Public Input No. 1067-NFPA 1900-2020 [Global Input]

Public Input No. 105-NFPA 1900-2020 [Section No. 57.1.3.1]

Figure 59.21.3.3.1 Dimension Lines for Measuring Seat Belt Effective Length.

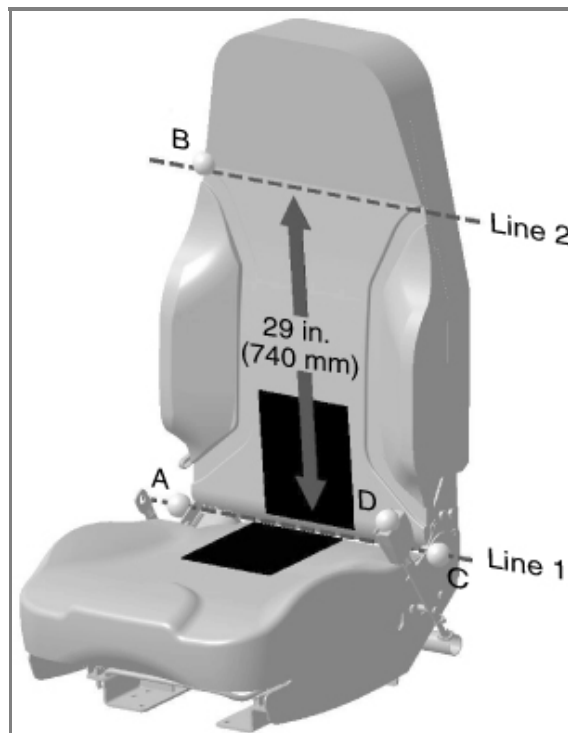
This text is being deleted as it is already covered by SAE J3026 and is not necessary to have as part of the requirements of this chapter. This text was borrowed from NFPA 1901 before SAE J3026 was available and the existing text is also geared towards occupants in the patient compartment that might be wearing a structural fire fighter protective garments and the need for longer seatbelt lengths. There is text being added to the annex to point end users to the specific chapter within NFPA 1900 that would applicable should a department desire longer seatbelts.

Statement: This text is being deleted as it is already covered by SAE J3026 and is not necessary to have as part of the requirements of this chapter. This text was borrowed from NFPA 1901 before SAE J3026 was available and the existing text is also geared towards occupants in the patient compartment that might be wearing a structural fire fighter protective garments and the need for longer seatbelt lengths. There is text being added to the annex to point end users to the specific chapter within NFPA 1900 that would applicable should a department desire longer seatbelts.

Figure 60.9.3.2 Warning Zones for Optical Warning Devices.

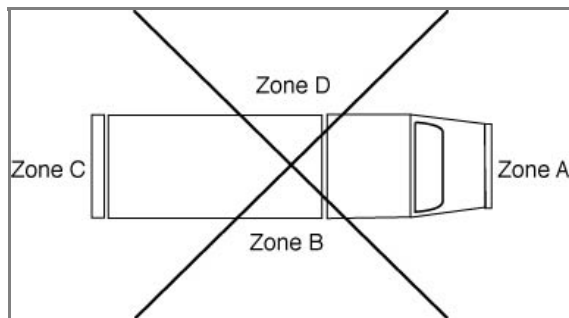
(REMOVE) The optical warning system shall consist of an upper and a lower warning level.

(REMOVE) The requirements for each level shall be met by the warning devices in that particular level without consideration of the warning devices in the other level.

(REMOVE) For the purposes of defining and measuring the required optical performance, the upper and lower warning levels shall be divided into four warning zones.

Figure 60.9.3.2 Warning Zones for Optical Warning Devices.

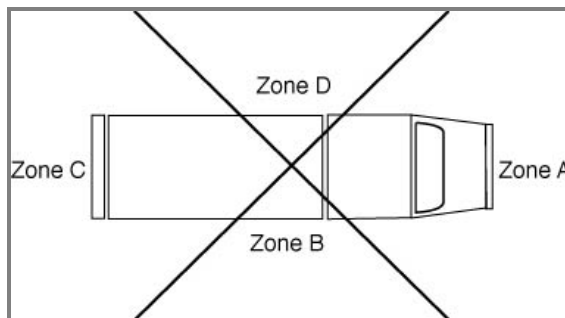
[REVISE FIGURE 60.9.3.2 SIMILAR TO FIGURE 16.8.3.2]

A number of comments were received for NFPA 1901 and NFPA 1906 that this diagram was confusing, with almost no lights counting towards Zone B and Zone D because of the way the lines were drawn. The suggested changes would make the description in this section consistent with the description of the same thing for fire apparatus. This figure, and the description in this section, refer to the direction of light projection, not the physical locations of device mountings.
